October 18, 2014

RE: Res-1729 Liquor License Application for the Eagle Street Grille, LLC
d/b/a The Salt Cellar at 173 Western Avenue North

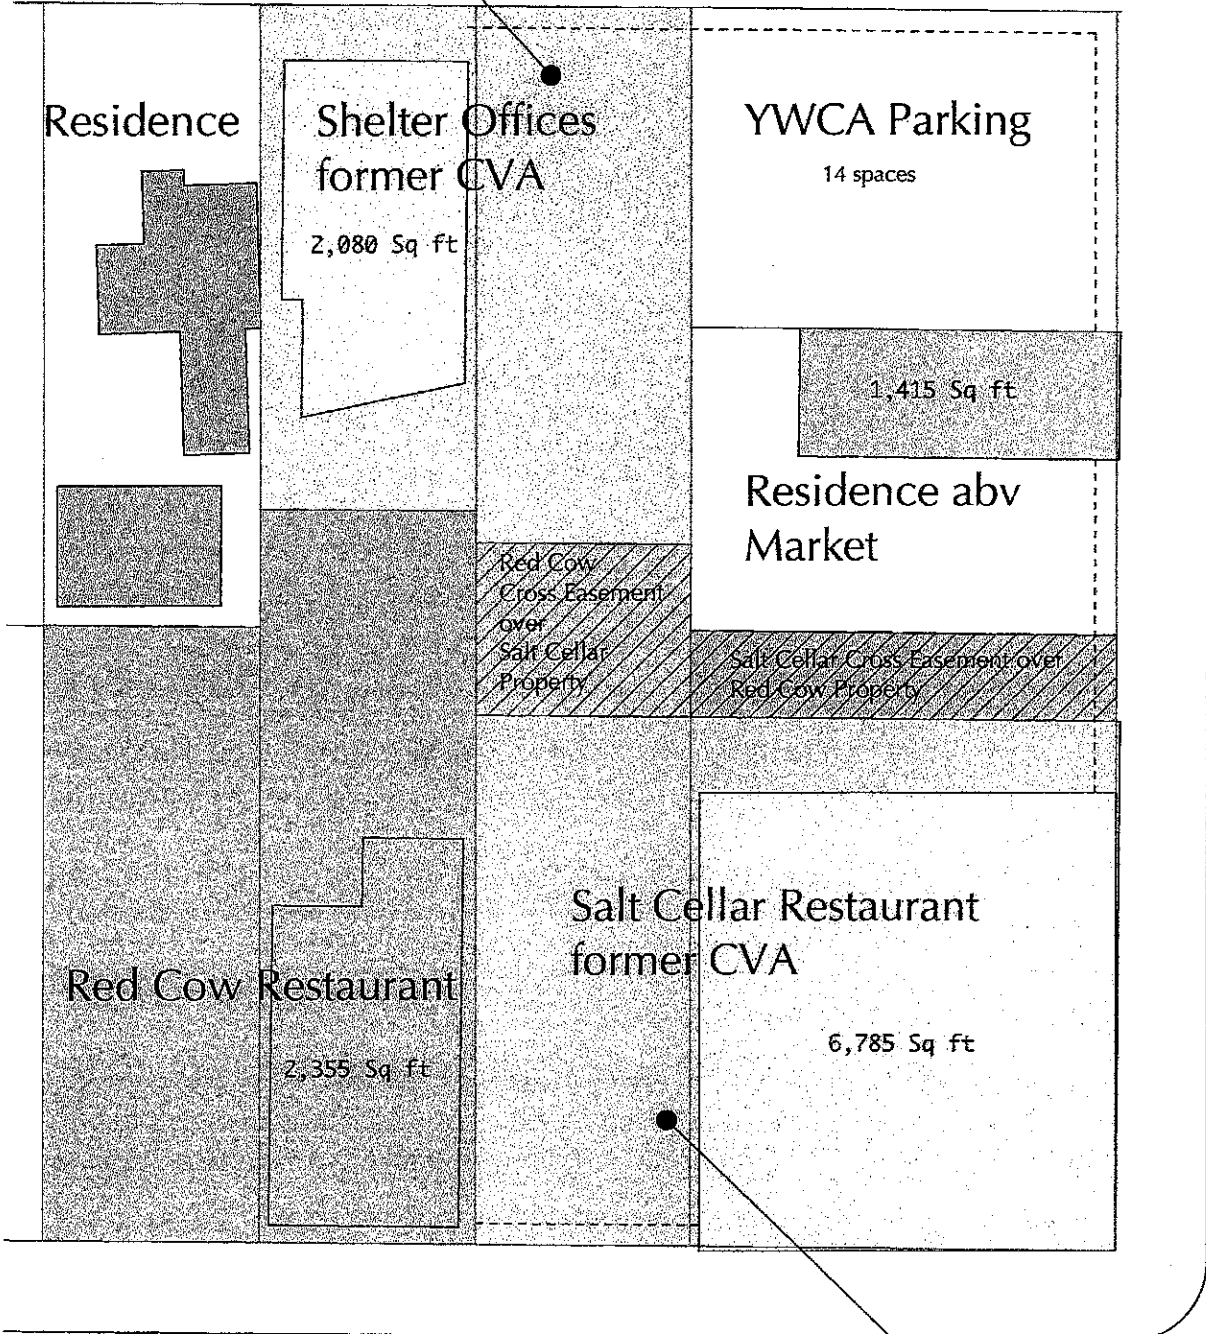
63 documented students = 21 spaces
6 staff @ 1 space per 2 = 3spaces
Total former spaces= 24 Spaces

13,600 gsf @ 1/400 s.f.= 34 Spaces

NOTE from CT: After visiting the site, I attempted to calculate the possible available legal off-street parking spaces on the neighboring property (385 Selby, owned by Selby Dayton LLC). The following page is an example of what I was able to come up with (10 (9x18) parking spaces including one ADA parking space).

The items and notes in red are modifications based on numbers found in City and County records
